Gewicht (errechnet) / Calc WT : Prüfmäß / Testdimension				Zul. Abw./Tolerances : DIN / ISO 1375				Maßstab / Scale : A3								
Teileindex / Partindexnumber:				ISO 2768-C				CUSTOMER DRAWING								
Bagatelle change:								Female receptacle Quicklock two-hole flange, solder type								
				24	Datum / Date		Name									
				Gez.	28.09.		Lee									
				Drawn												
				Gepr.												
				Checked				M C091 31TXXX XOY 5 U								
				Amphenol-Tuchel Industrial GmbH				Blatt / Sheet 1								
01 CATI-202306002				28.09.24		Lee		Ers. f. / Replacement for :								
Index		Änderung / Description		Datum / Date		Name		1 BL

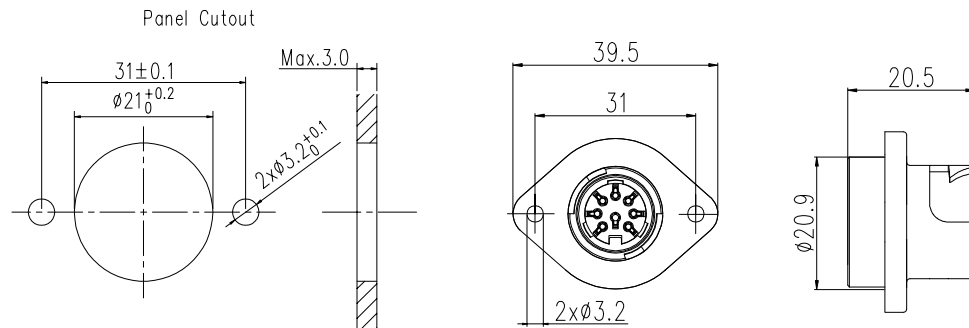
Sealing area must be flat and polished.
provide suitable sealing for the screws

After soldering wires on the insert with contacts, then we press it into the housing
